February 15, 2024

Industrial Device Business Division,
Panasonic Industry Co., Ltd.

〈Notification〉 Add Supplier of Oil seal for MINAS A6 Series

Appendix 1

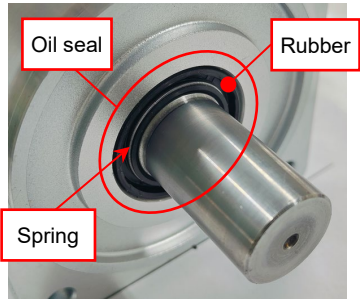
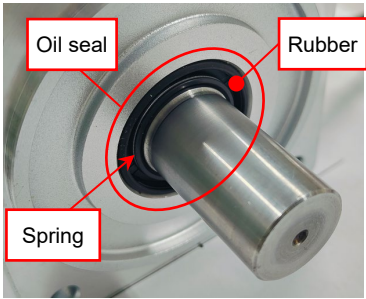
When the oil seal is changed, the characteristics, performance, dimensions recorded in the appearance dimension diagram, protective performance, and service life are no changed of the Servo Motor.

Before	After (Add)
Supplier	NOK CORPORATION	NAK Kunshan Maoshun Sealing Products Industrial Co., Ltd
Rubber material	NBR	NBR
Spring material	SWP (JIS G3522-1991)	SWP (JIS G3522-1991)
Using part		 <ul style="list-style-type: none"> • After is blacker than Before. • After's spring is more difficult to see than Before's. <p>(Does not affect the oil seal of performance.)</p>
